Subject: Duane Arnold Energy Center
Docket No: 50-331
Op. License No: DPR-49
Response to Request for Additional Information (RAI) to Request for
Operating License Change (TSCR-040) – Revised Thermal-Hydraulic
Analysis for the Spent Fuel Pool. (TAC # MB0596)

DAEC's Response to
NRC Staff's Request for Additional Information
Regarding the Thermal-Hydraulic Evaluation of the DAEC Spent Fuel Pool

Figure 1 - Reactor Heat Generation for Cases 1 and 2 from Revision 4

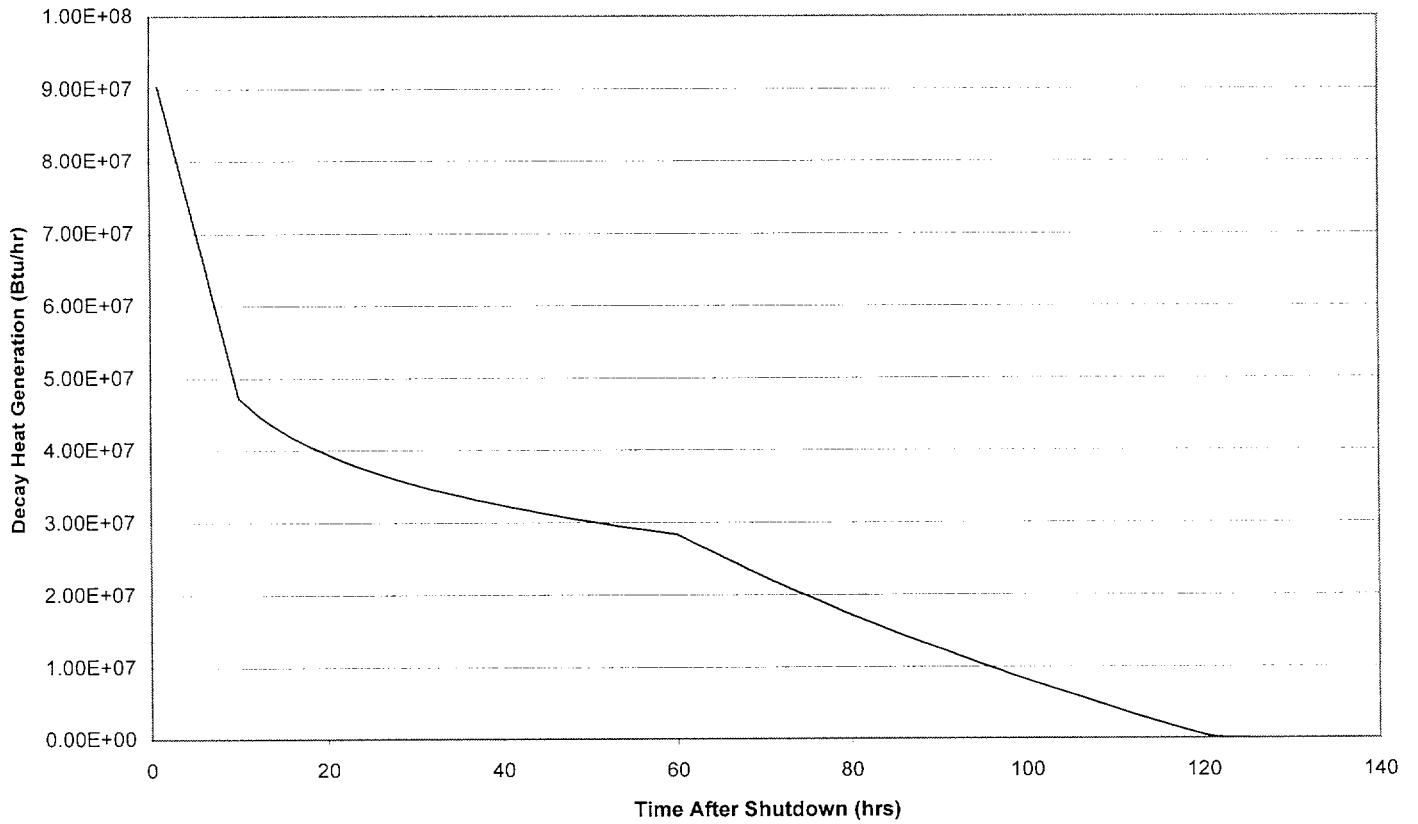
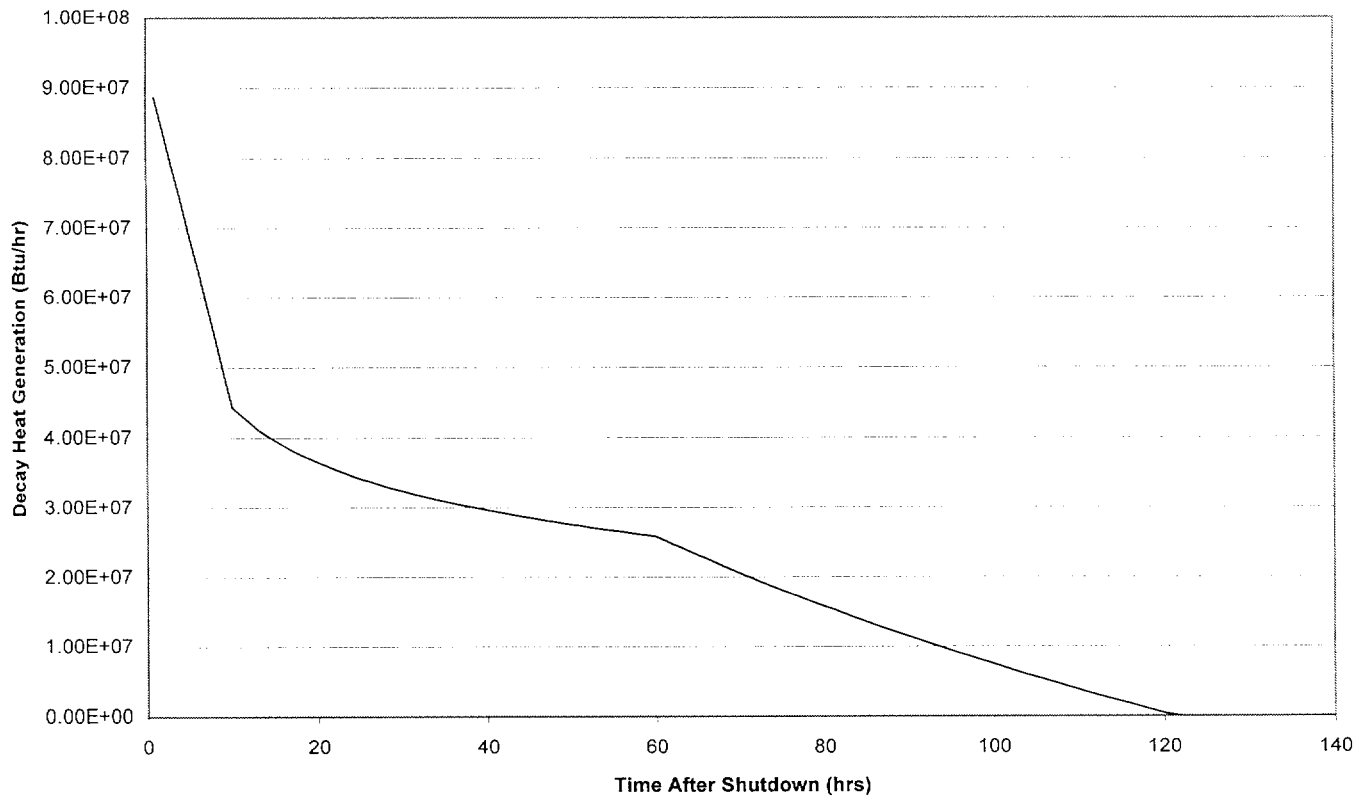
4. With regard to the decay heat in the reactor cavity vessel, please provide the following additional information.
 - a. The decay heat in the reactor vessel cavity as functions of time (similar to Figures 4-6) for all scenarios analyzed. This information is needed since the RHR removes the heat from both reactor vessel cavity and SFP.
 - b. The decay heat in the reactor cavity vessel of the same cases for Revision 2 for comparison.

See Attachment 2, Figures 1 and 2 for reactor decay heat curves from Revision 4 and Figure 3 for the reactor decay heat curve from Revision 2.
